STAFF RECOMMENDATION 1008 Lawrence Avenue January 20, 2021

Application: New Construction—Addition

Description of Project: Applicant proposes to construct a rear addition that extends wider than the historic house.

Figure 2. The proposed alterations to the window openings.

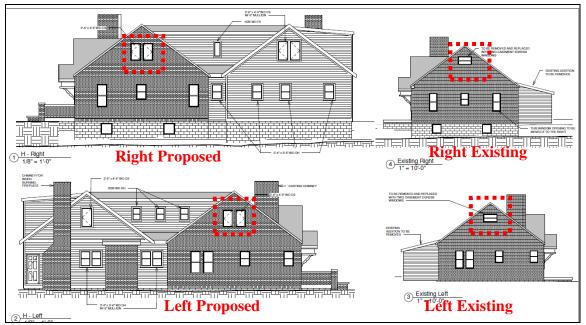
<u>Demolition</u>: The applicant proposes to alter window openings in the gable fields of the side facades, which is considered partial demolition (Figures 2). The new windows will allow for egress and are an appropriate size and scale. The applicant also intends to move a window on the right side façade towards the rear three feet (3') forward on this façade. Staff finds that this is a minor change, at the rear, which meets the design guidelines. Because the alterations are relatively small and the windows are an appropriate size and scale, staff finds the proposed partial demolition of the walls for the new window openings to meet the design guidelines.

Staff finds that the proposed window alterations and the removal of the rear extension are appropriate demolition, meeting Section V.B.2. of the design guidelines.

Figure 3 (Left) shows the rear extension to be removed and Figure 4 (Right) shows the 1957 Sanborn map where this rear extension has different dimensions.

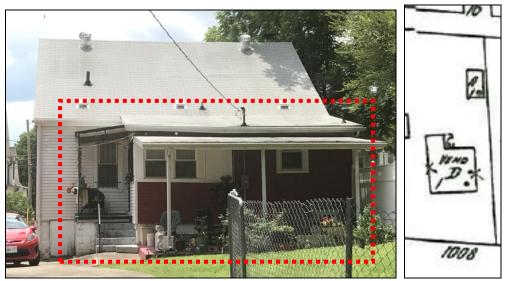
The applicant also intends to remove an existing rear extension (Figure 3). The date of construction of the extension is not known, but it does not seem to match the footprint of

the 1957 Sanborn map (Figure 4). In any case, the existing rear extensions separate shed roof form and its location at the rear do not contribute to the historic and architectural integrity of the historic house. Staff therefore finds that its removal is appropriate demolition under the design guidelines.

ELEVATIONS		
Date	1/8/21	H2
Drawn by	J. Feller	
		Scale 1/8" = 1'-0"

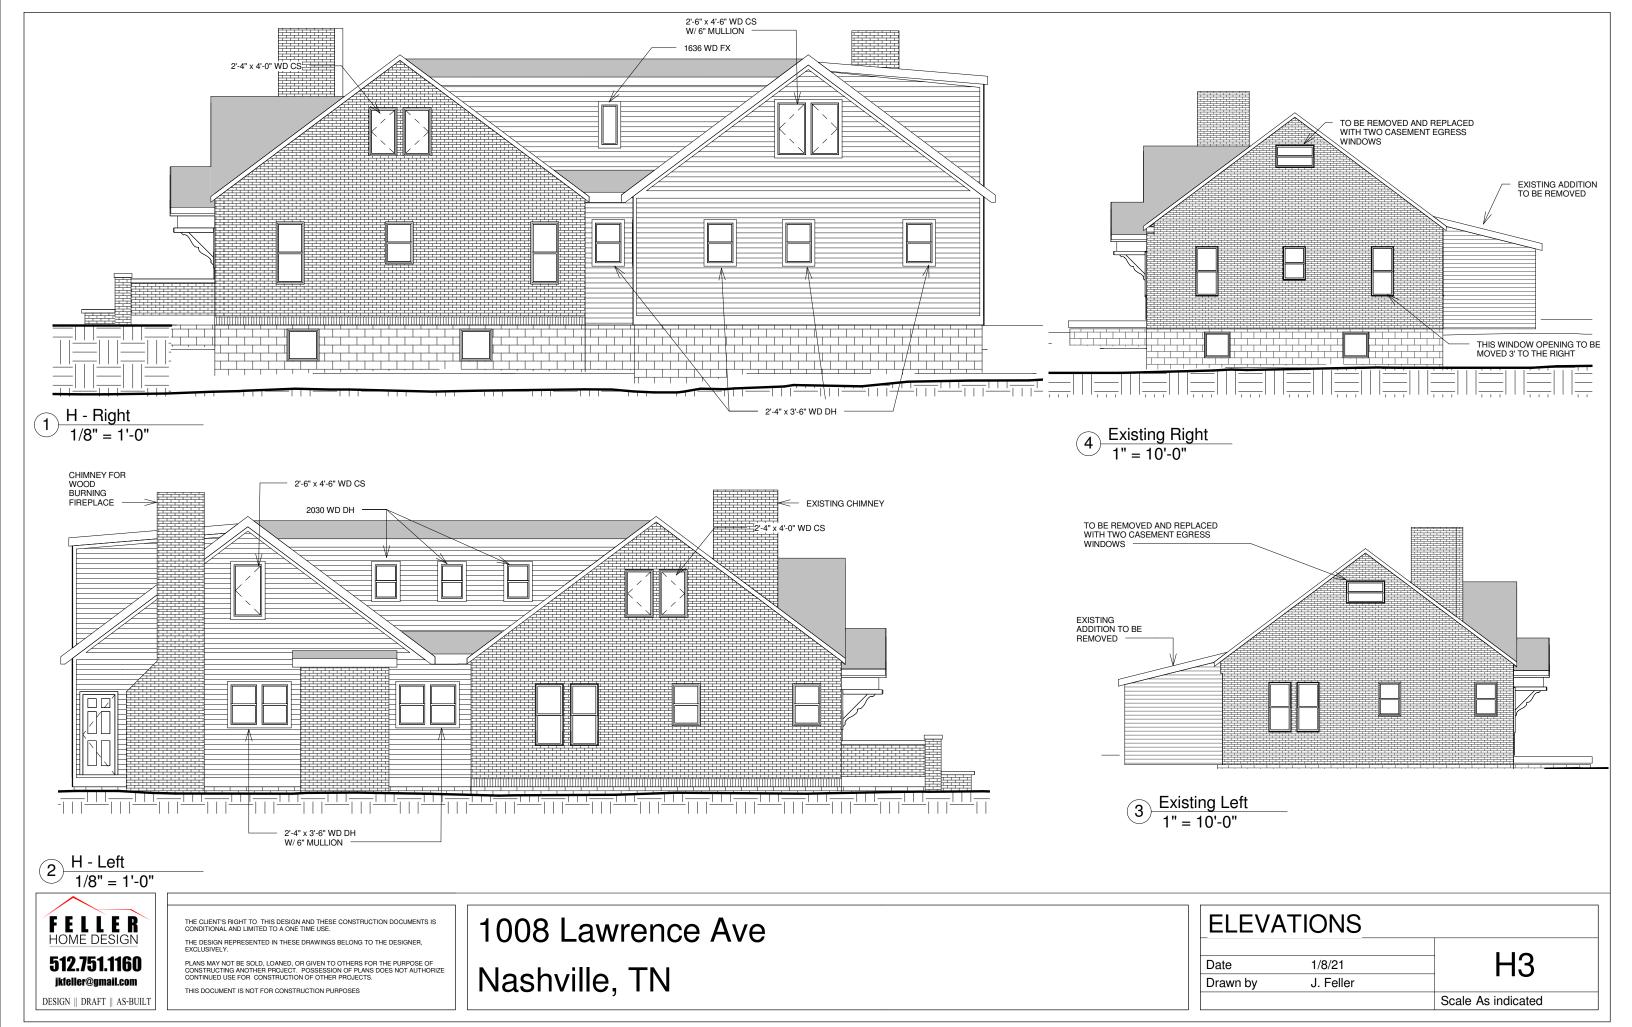
<u>Height & Scale</u>: The addition is one-and-half-stories in height, matching the scale of the historic house. The addition's foundation, eaves, and ridge heights all match those of the historic house. The addition will be inset two feet (2') from the back corners of the house. The left side will be inset two feet (2') for its entire depth. The right side will step back out to be seven feet, two inches (7'2") wider than the historic house after a depth of four feet (4'). Staff finds that the wider portion meets the design guidelines because the house is shifted significantly on the lot, and the addition is no taller than the historic house.

<u>Roof form</u>: The addition's primary roof form will be an 8/12 side gable that matches the historic house's side gable. The addition will tie into the back slope of the house's gable with a low slope connector. The rear shed dormer will be inset two feet (2') from the walls of the addition. Staff finds that these roof forms are compatible with the historic house's roof form.

<u>Proportion and Rhythm of Openings</u>: The changes to the windows on the historic house were discussed under "Partial Demolition." The windows on the proposed addition are all generally twice as tall as they are wide, thereby meeting the historic proportions of openings. There are no large expanses of wall space without a window or door opening.

Overall, staff finds that the addition's height and scale to meet Sections III.A., III.B., and IV.B. of the design guidelines.

Staff finds that the proposed roof forms meet Sections III.E. and IV.C of the design guidelines.

Staff finds the project's proportion and rhythm of openings to meet Sections III.G. and IV. of the design guidelines.

Floor Plan			
Date Drawn by	1/8/21 J. Feller	H4	
		Scale 1" = 10'-0"

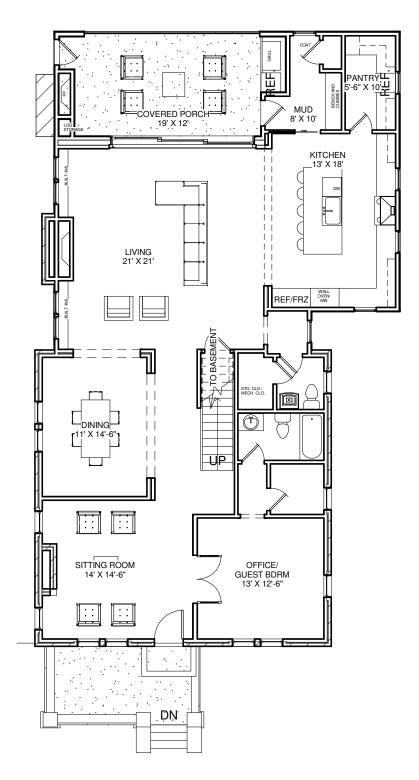
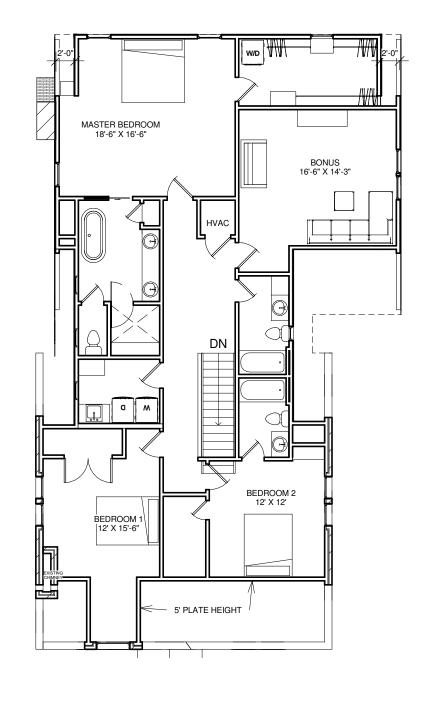
The historic house has a footprint of approximately nine hundred and sixty-one square feet (961 sq. ft.), not including the addition that will be removed, which is two hundred and ten square feet (210 sq. ft.). The new addition has a footprint of approximately one thousand, one hundred and fifty square feet (1,150 sq. ft.). There will be a net increase of nine hundred and forty square feet (940 sq. ft.) of footprint when the removal of the existing addition is taken into consideration.

<u>Location & Removability</u>: The addition is located behind the historic house, and only extends wider after an appropriate two foot by four foot (2' X 4') inset. The addition's insets and separate roof form ensure that the addition could be removed in the future without detrimentally affecting the historic character of the historic house.

Staff finds that the addition's location and removability to meet Sections IV.A. and IV.F. of the design guidelines.

Site - F	Proposed_	
Date	1/8/21	H5
Drawn by	J. Feller	Scale 1" = 20'-0"

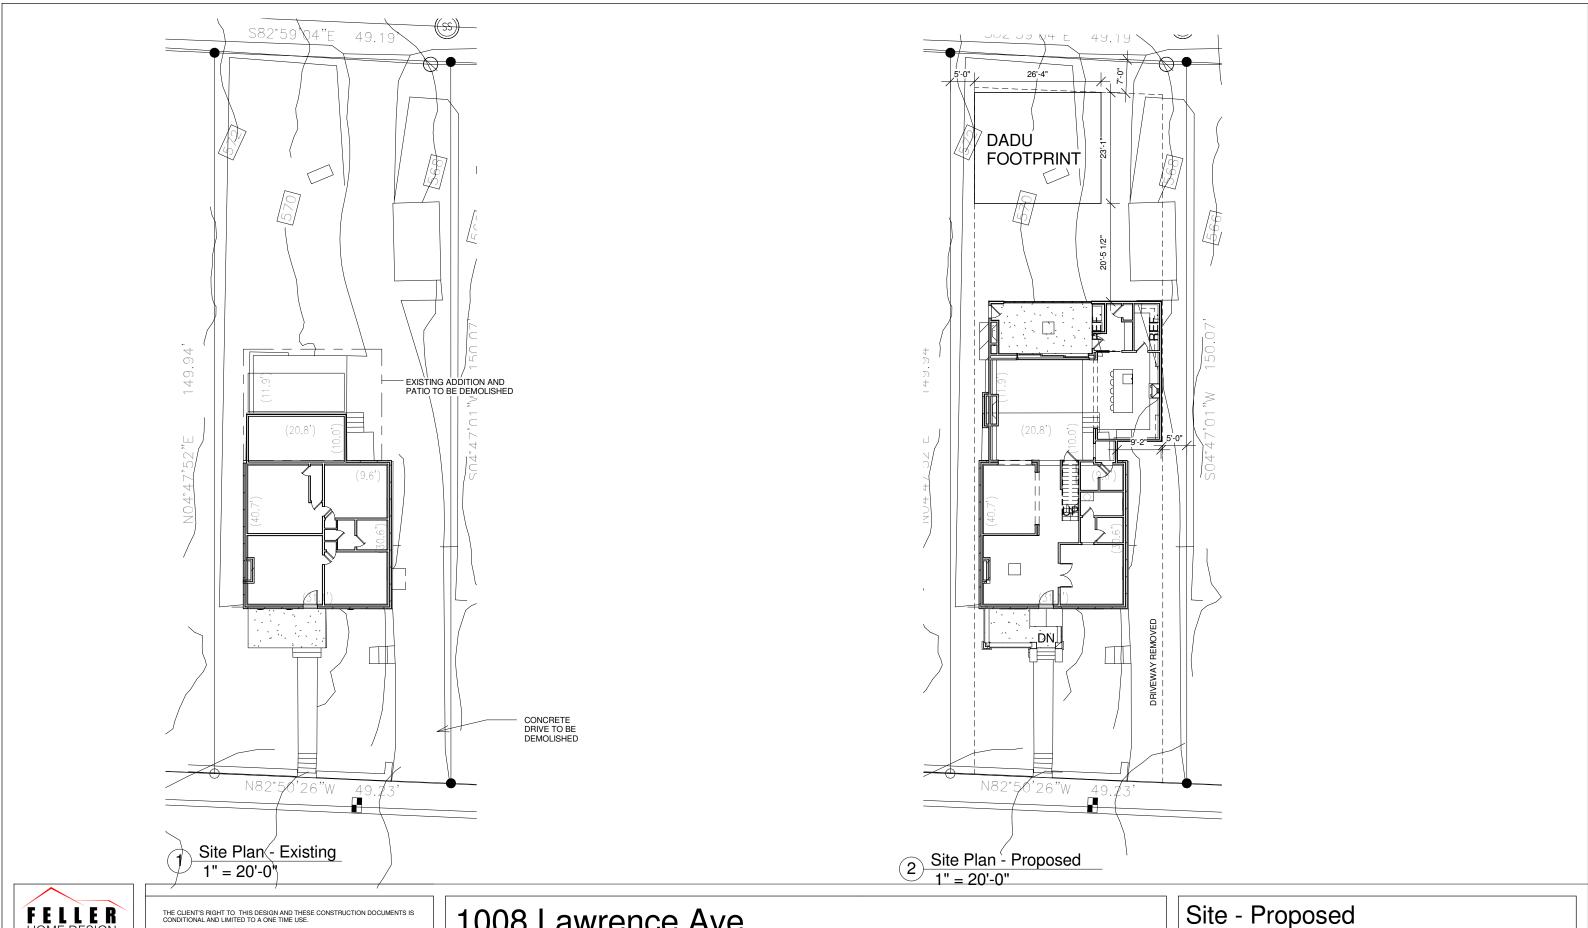
<u>Setback & Rhythm of Spacing:</u> The addition meets all base zoning setbacks. It will be eight feet (8') from the left side property line, five feet (5') from the right-side property

line, and approximately fifty feet (50') from the rear property line. The new side addition will not affect the house's rhythm of spacing along Lawrence Avenue.

<u>Orientation</u>: The existing driveway from Lawrence Avenue will be removed and vehicular access to the site will be from the alley. No other changes to the house and site's orientation will result from this project.

<u>Appurtenances & Utilities:</u> No changes to the site's appurtenances were indicated on the drawings. The location of the HVAC and other utilities was also not noted. Staff recommends approval of the location of the HVAC unit and all utilities prior to purchase and installation.

Staff finds that the proposed setbacks and rhythm of spacing to meet Sections III.C. and IV. of the design guidelines.

Staff finds that the addition's orientation to meet Sections III.F. and IV. of the design guidelines.
